TOWN OF CORTLANDT PLANNING BOARD

WORK SESSION.....JULY 1, 2025 6:00 PM

MEETING AGENDA.....PLANNING BOARD
TOWN OF CORTLANDT
6:30 TUESDAY EVENING*
JULY 1, 2025

EXISTING VIEW 1

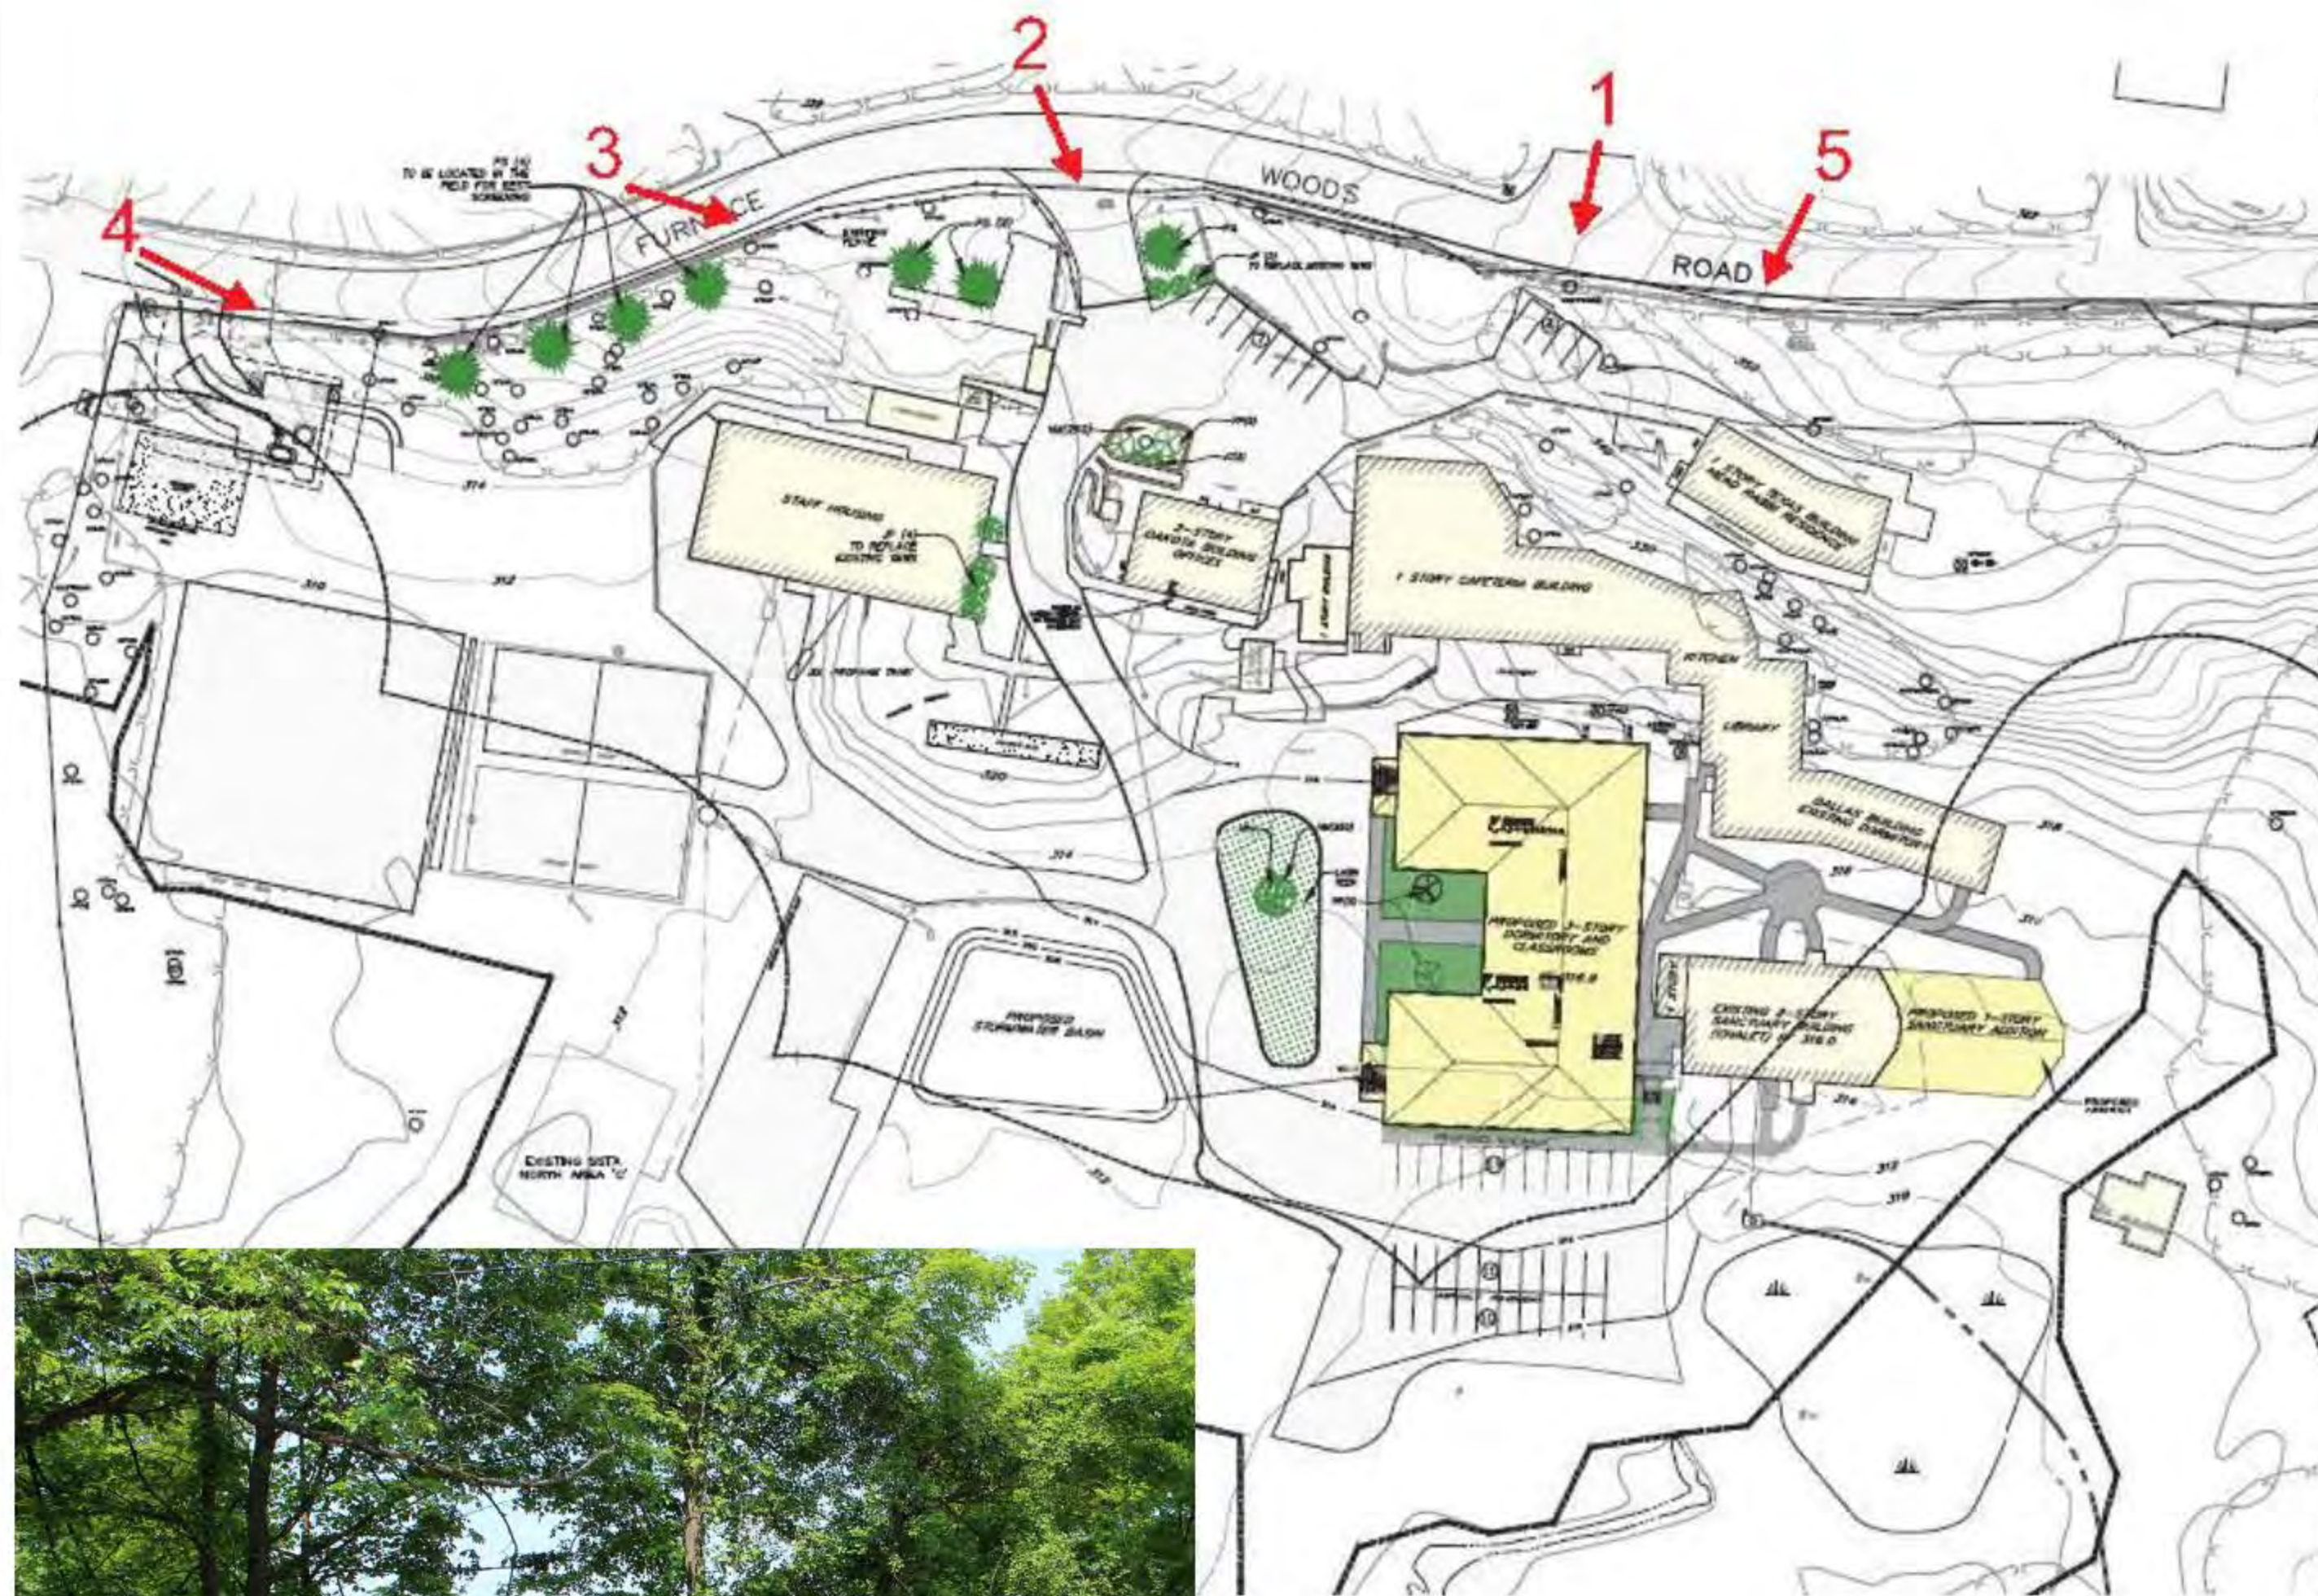
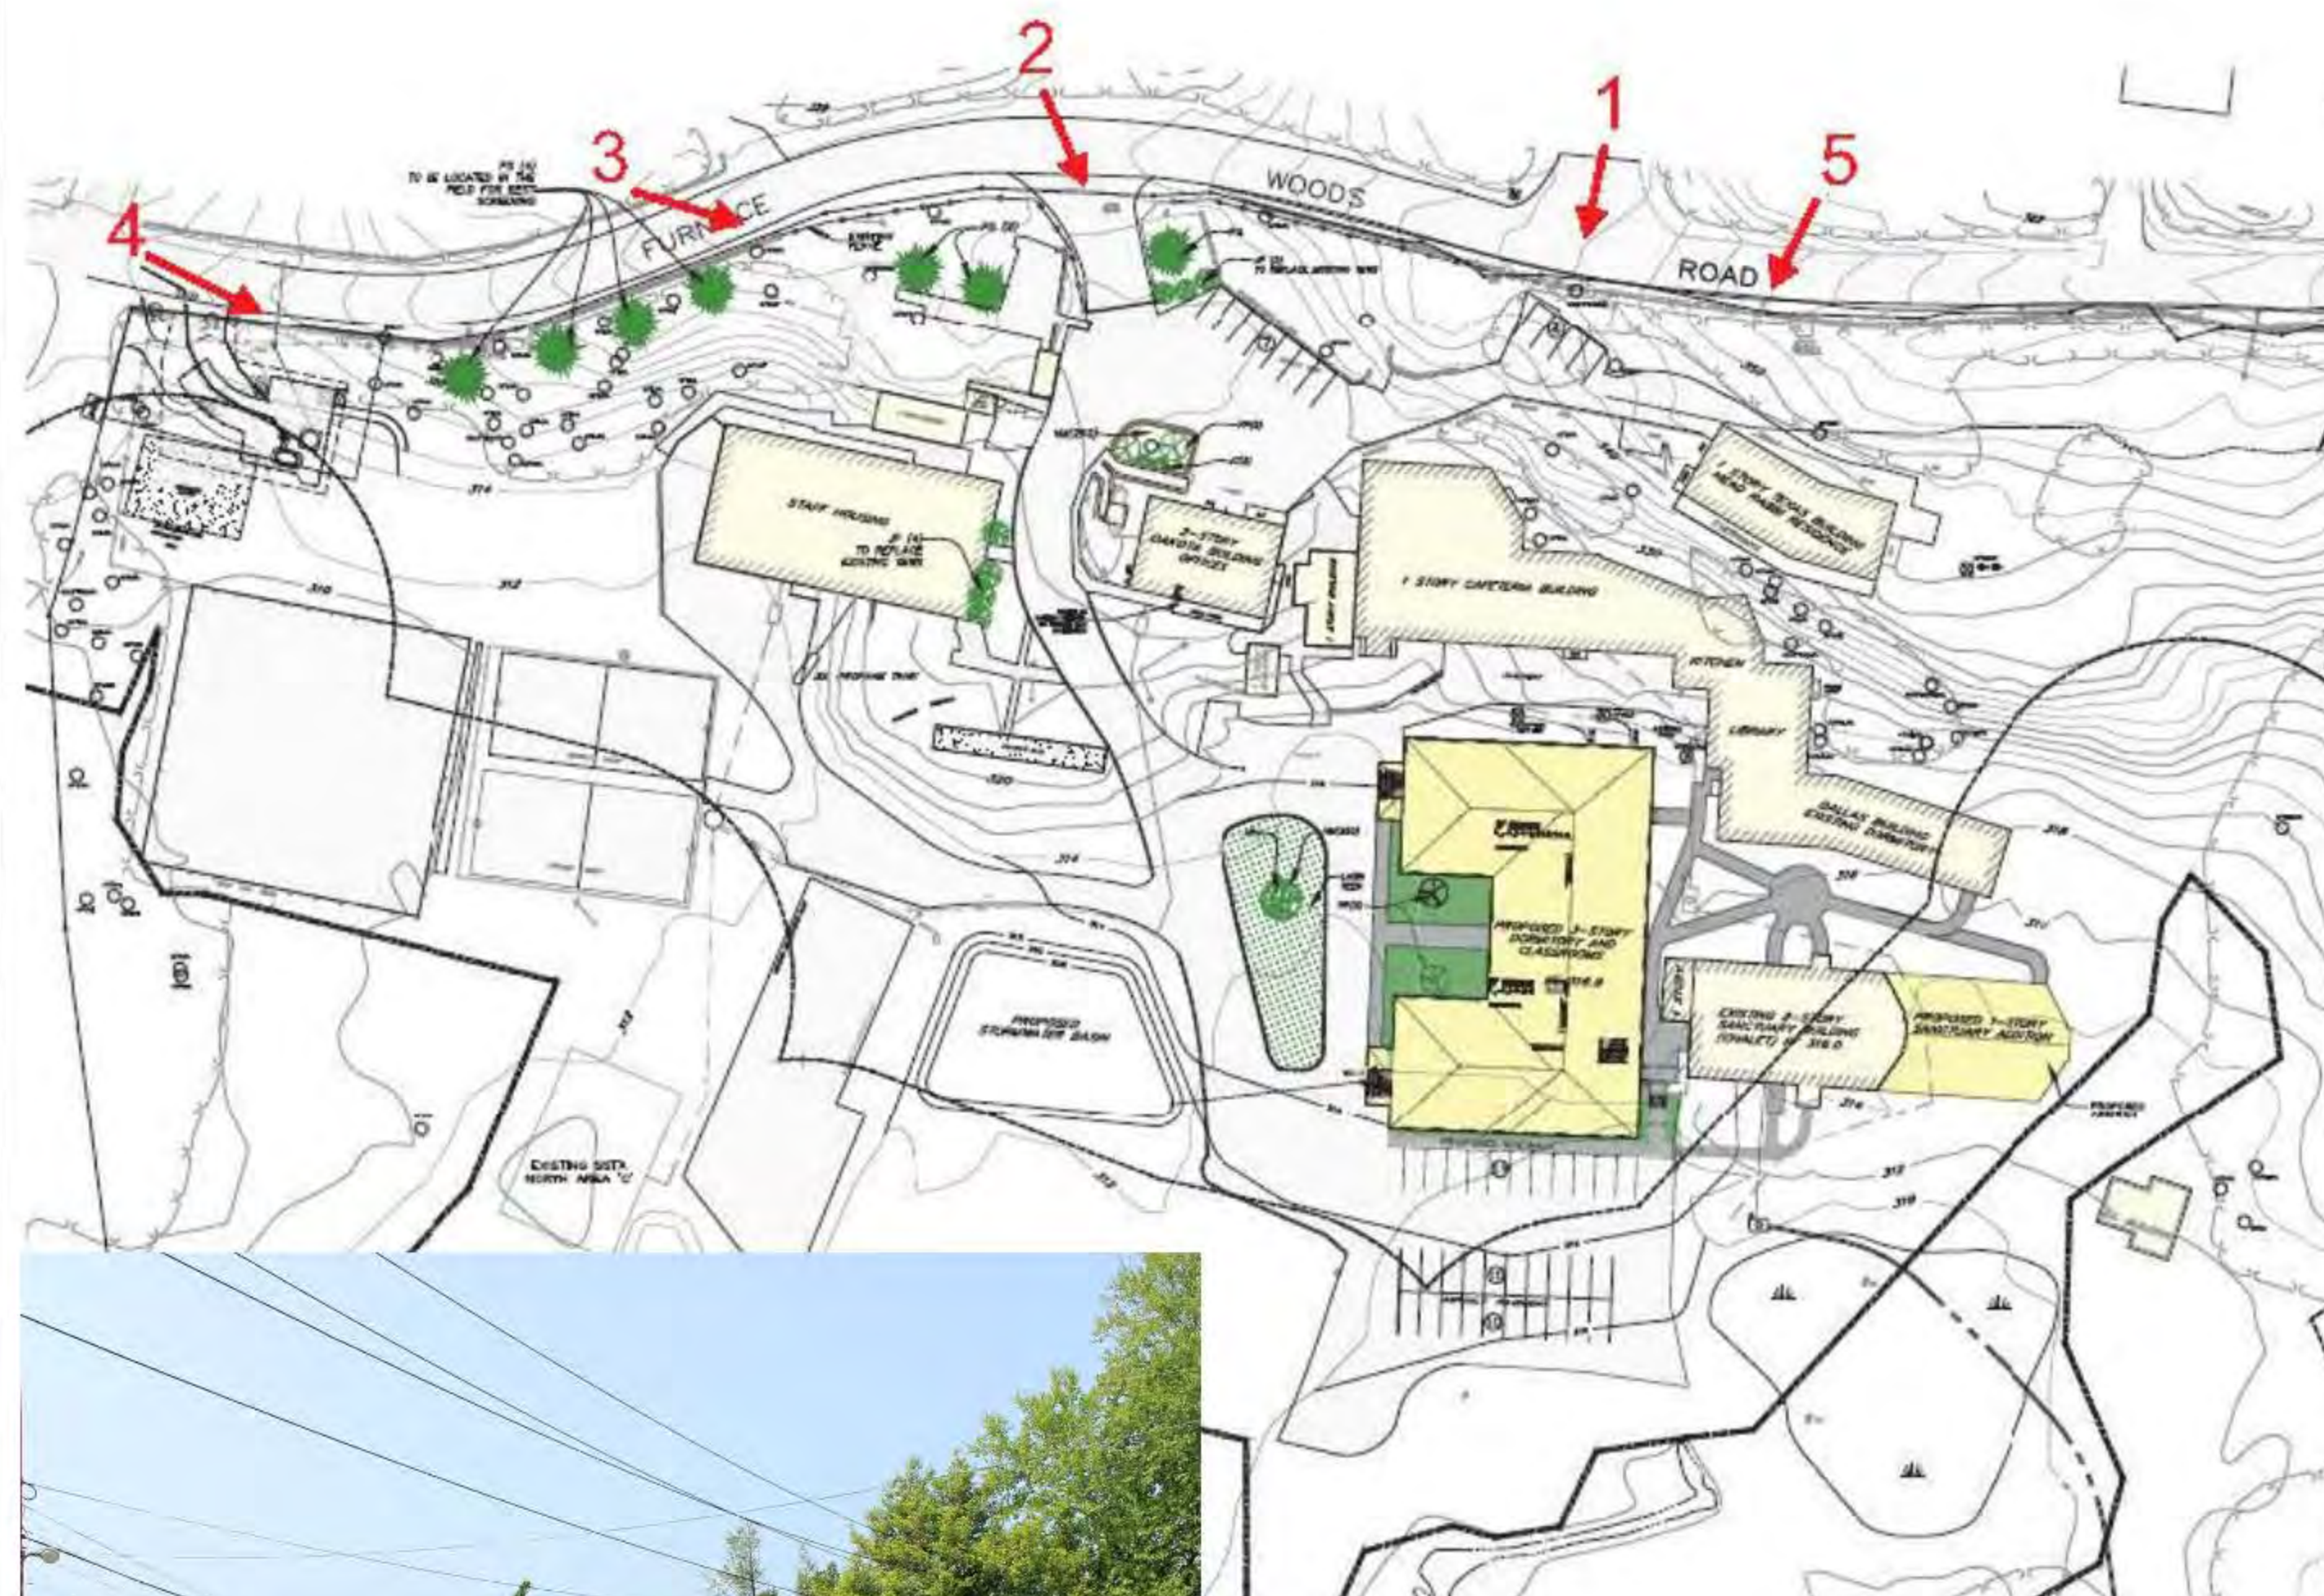
2. **Visual Impacts:** At their May meeting, the Planning Board requested the applicant provide views of the new dormitory building from the nearby public road. Views should be shown from multiple points along Furnace Woods Road, in both leaf-on and leaf-off conditions. In addition to the site line shown on Sheet 7, we suggest capturing views southbound from the vicinity of 165 Furnace Woods Road, northbound from the vicinity of 130-136 Furnace Woods Road, and from the site entrance.
